Preliminary VALUE ENGINEERING STUDY REPORT

I-35E Managed Lanes Project

REPORT DATE: September 2010

| TITLE: Defer wishbones and use slip ramps instead (where applicable) | | NUMBER 3.0 (P-7) | PAGE NO. 3 of 7 |

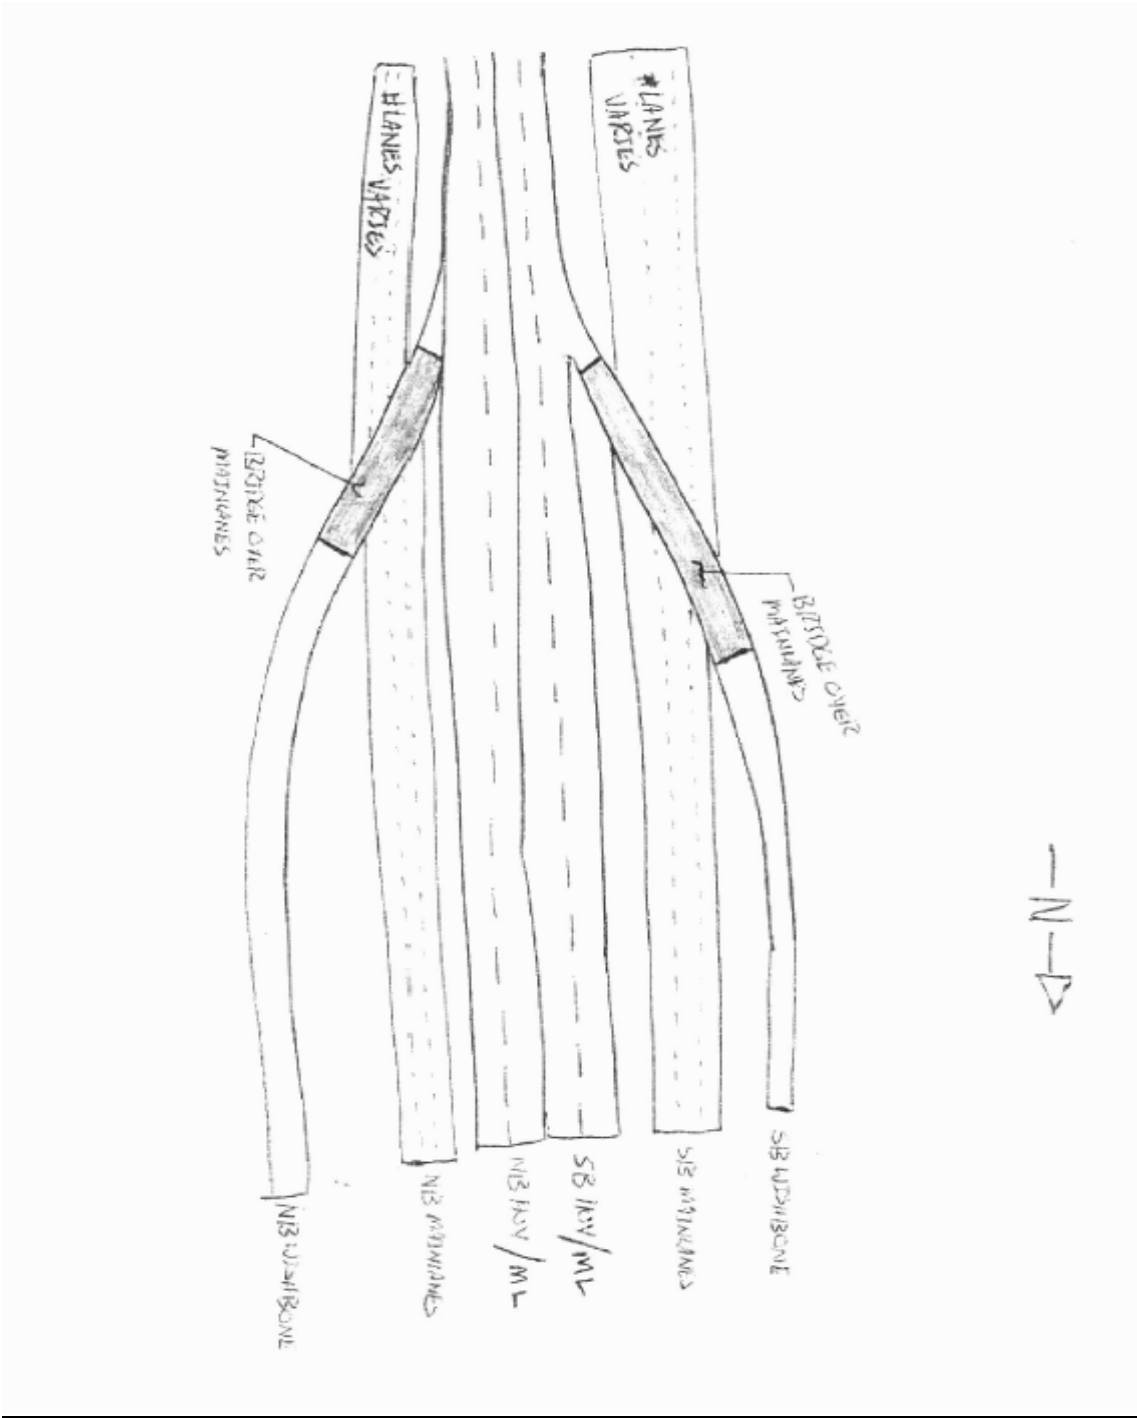
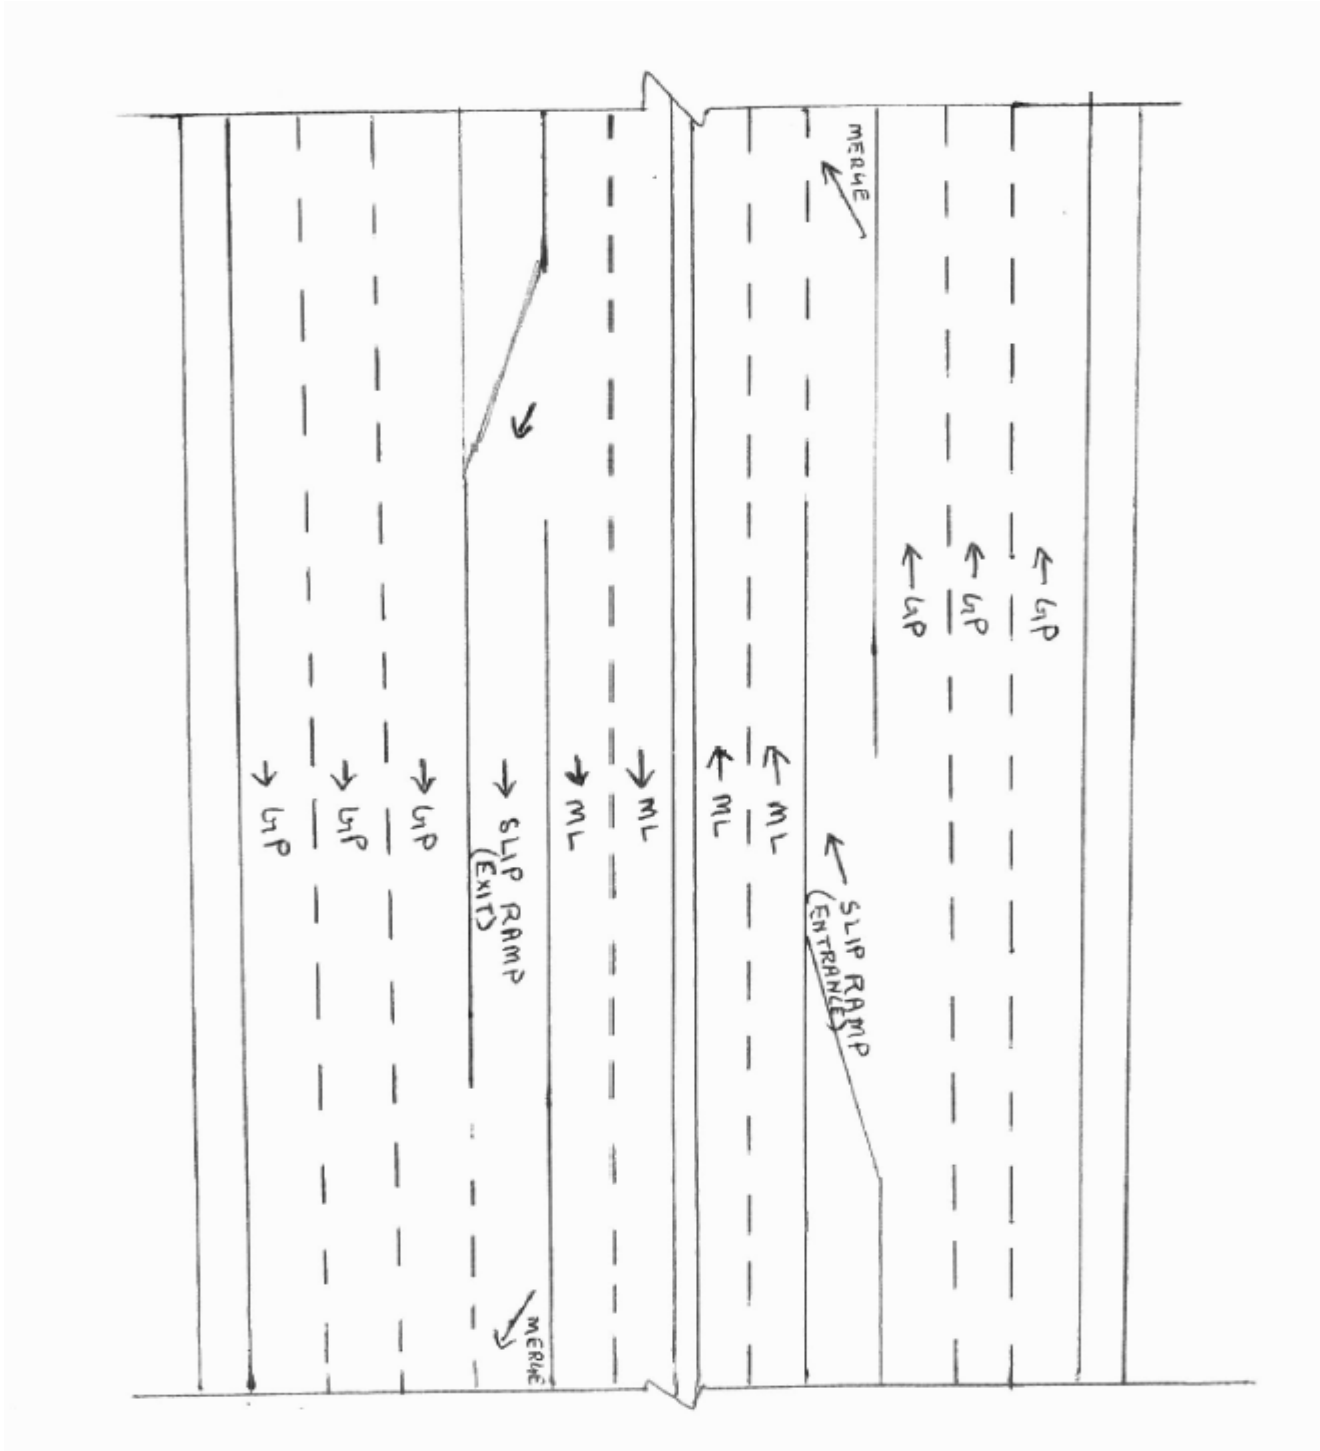
| Team Member: Michael Kerrigan <input type="checkbox"/> I have reviewed this alternative and agree with it as it is written <input checked="" type="checkbox"/> I have reviewed this alternative and suggest the following (or attached) changes Should indicate merge distance on drawing | | |

| <input type="checkbox"/> I have reviewed this alternative and agree with it as it is written <input checked="" type="checkbox"/> I have reviewed this alternative and suggest the following (or attached) changes The # of lanes do not add up. Verify. | | |

| <p>TITLE: Revise wishbone design (instead of going over, go under)</p> | <p>NUMBER 10.0 (M-10)</p> | <p>PAGE NO. 3 of 6</p> |

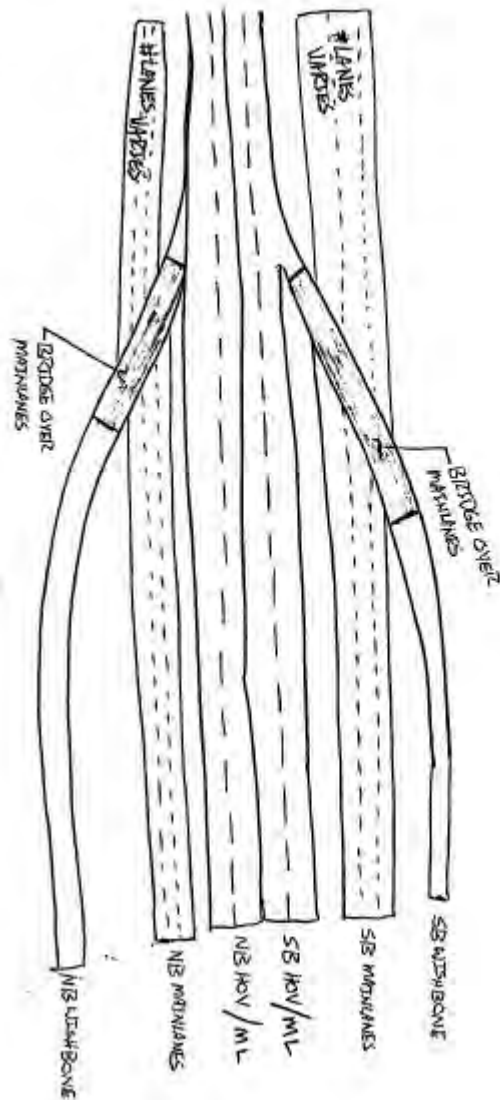
| Team Member: Spenta Irani <input type="checkbox"/> I have reviewed this alternative and agree with it as it is written <input checked="" type="checkbox"/> I have reviewed this alternative and suggest the following (or attached) changes Questions on cost difference? |

Figure1. Project Map

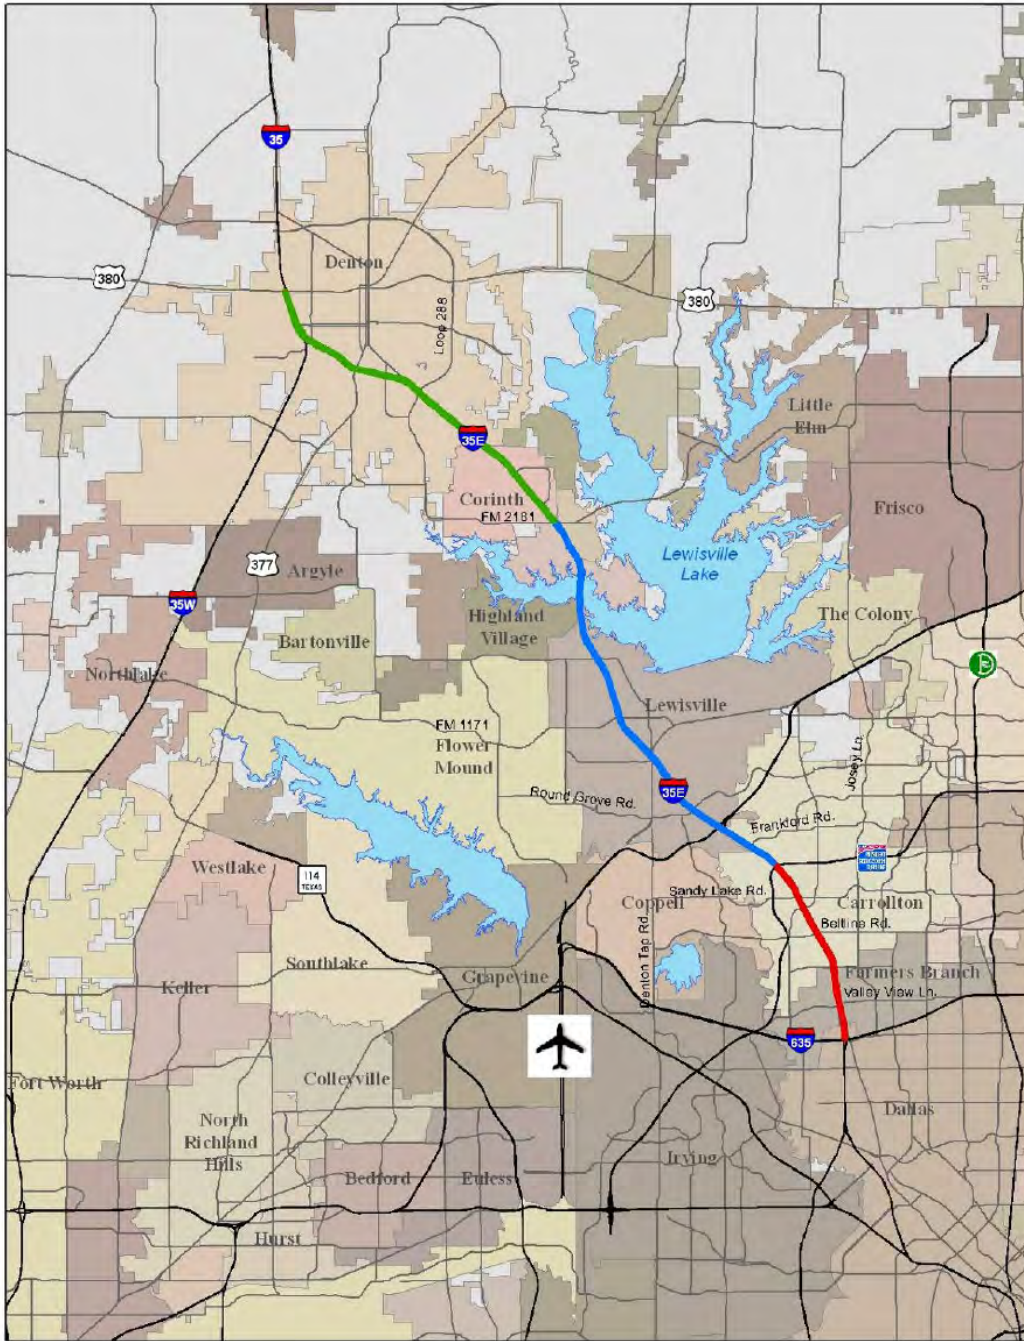
Comment [D1]: Can we add a north arrow and a legend and/or big labels that show South Segment, Middle Segment, and North Segment?
